# FINAL PLAT

## HAWTHORNE FOURTH ADDITION

RE: SUB 2004-76 -- One-Step Final Plat of Hawthorne Fourth Addition

**CASE NUMBER:** SUB 2004-76 -- HAWTHORNE FOURTH ADDITION

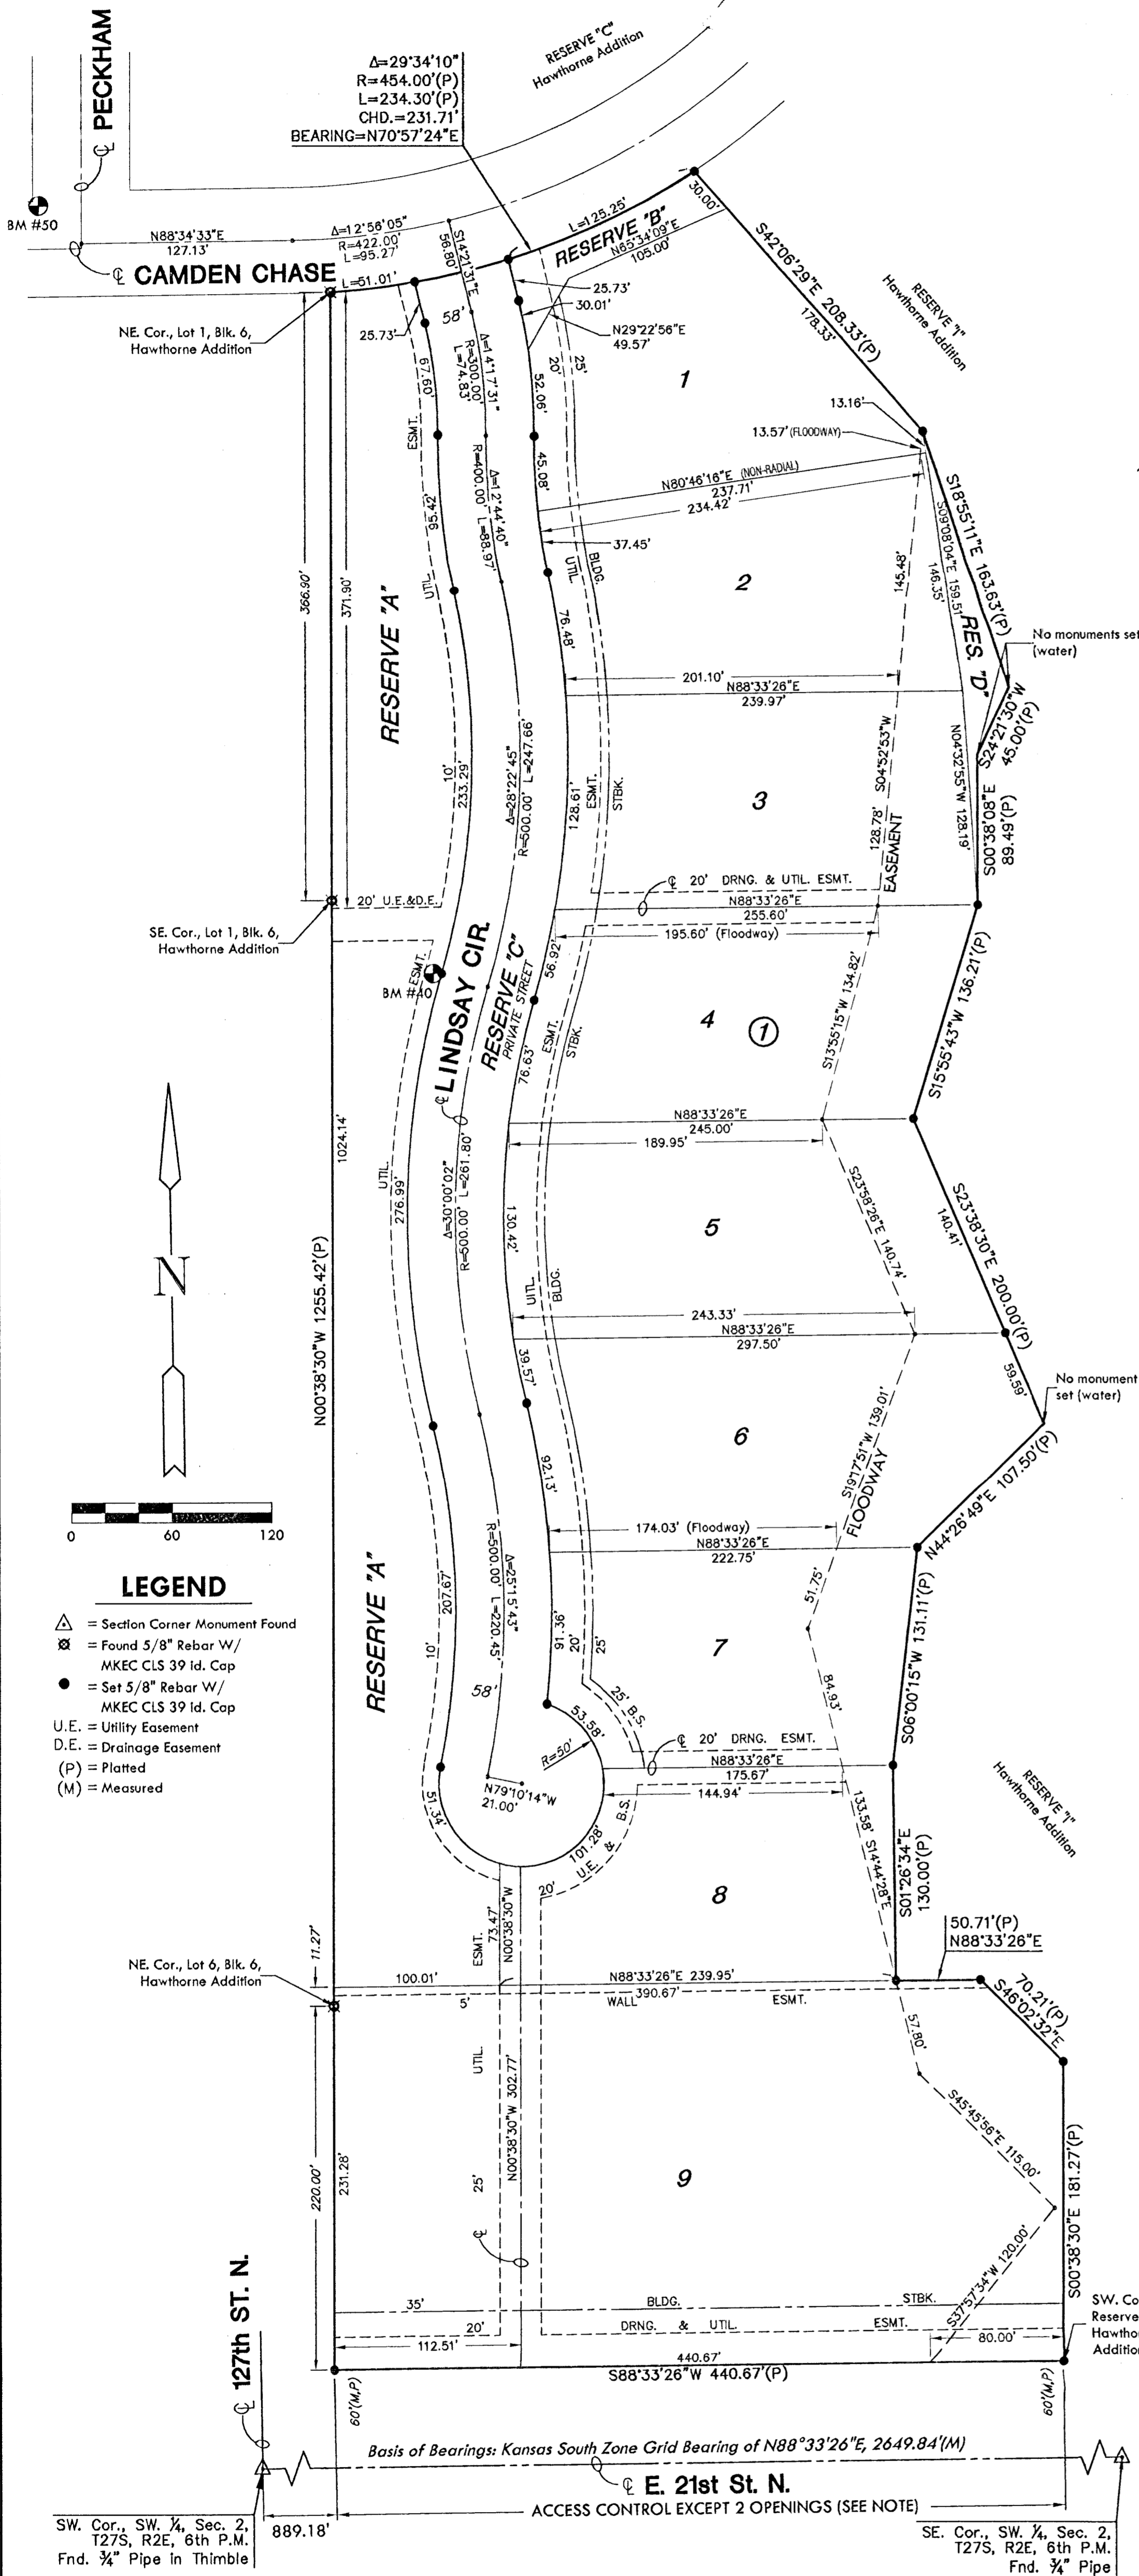
At the regular meeting of the Subdivision Committee of the Metropolitan Area Planning Commission on Thursday, July 1, 2004, the above captioned plat was considered. The action of the Committee was to approve the one-step final plat, subject to the following staff comments:

- A. Petitions have been provided with Hawthorne Addition for sewer, water, drainage and paving improvements. *New petitions are needed for future improvements.*

- B. *Debt Management* has requested the submission of a respread agreement for special assessments due to the lot reconfiguration.
- C. If improvements are guaranteed by petition, a notarized certificate listing the petitions shall be submitted to the Planning Department for recording.

- D. *City Engineering* needs to comment on the status of the applicant's drainage plan. *The drainage plan is approved.*
- E. *Traffic Engineering* has requested a petition for turn lanes

- F. Lot 9 is bi-zoned with the east 319.73 feet zoned GO, General Office. Either a zone change shall be submitted for the remainder of the lot or a restrictive covenant shall be submitted limiting the uses on the western portion to those permitted in the SF-5 zoning district.

- G. The plat proposes two openings to 21<sup>st</sup> St. North. *Traffic Engineering has approved the two openings. A note on the plat shall specify that the two access points shall be placed in accordance with Access Management Standards pertaining to both sides of 21<sup>st</sup> Street.*

- H. *GIS* has requested the street name by labeled Lindsay.
- I. Provisions shall be made for ownership and maintenance of the proposed reserves. The applicant shall either form a lot owners' association prior to recording the plat or shall submit a covenant stating when the association will be formed, when the reserves will be deeded to the

association and who is to own and maintain the reserves prior to the association taking over those responsibilities.

- J. Since this is a replat of a previous Addition involved with the ownership and maintenance of reserves for that Addition, but not being replatted by this Addition, the above covenants and/or other legal documents shall be provided which provides for this Addition to continue to share in the ownership and maintenance responsibilities of any such previously platted reserves.

- K. For those reserves being platted for drainage purposes, the required covenant which provides for ownership and maintenance of the reserves shall grant, to the City, the authority to maintain the drainage reserves in the event the owner(s) fail to do so. The covenant shall provide for the cost of such maintenance to be charged back to the owner(s) by the governing body.

- L. The applicant shall submit a covenant which provides for four (4) off-street parking spaces per dwelling unit on each lot which abuts a 58-foot street. The covenant shall inventory the affected lots by lot and block number and shall state that the covenant runs with the land and is binding on future owners and assigns.

- M. A covenant shall be submitted regarding Reserve C, platted for private street purposes, which sets forth ownership and maintenance of the private street, and future reversionary rights of the reserve to the lots benefiting from the reserve.

- N. A restrictive covenant was recorded with the Hawthorne Addition guaranteeing the paving of the private street to a public street pavement standard. A new covenant needs to be submitted for this Addition.

- O. A non-masonry wall with a removable gate is required for the portion of the wall easement that crosses the 25-ft utility easement. The wall easement shall be referenced in the plat's text.

- Q. The plat's text shall include language that a drainage plan has been developed for the plat and that all drainage easements, rights-of-way, or reserves shall remain at established grades or as modified with the approval of the applicable City or County Engineer, and unobstructed to allow for the conveyance of stormwater.

- R. The applicant shall install or guarantee the installation of all utilities and facilities which are applicable and described in Article 8 of the MAPC Subdivision Regulations. (Water service and fire hydrants required by Article 8 for fire protection shall be as per the direction and approval of the Chief of the Fire Department.)

- W. Perimeter closure computations shall be submitted with the final plat tracing.
- X. Recording of the plat within thirty (30) days after approval by the City Council and/or County Commission.

East 21st Street North - Two access points for Lot 9, Block 1 shall be placed accordingly: The minimum distance between a full movement opening and a right-in/right-out drive shall be 200 feet. The minimum distance between a right-in/right-out drive and another right-in/right-out drive shall be 200 feet. Solid access points shall be in accordance with the Access Management Standards to both sides of 21st Street.
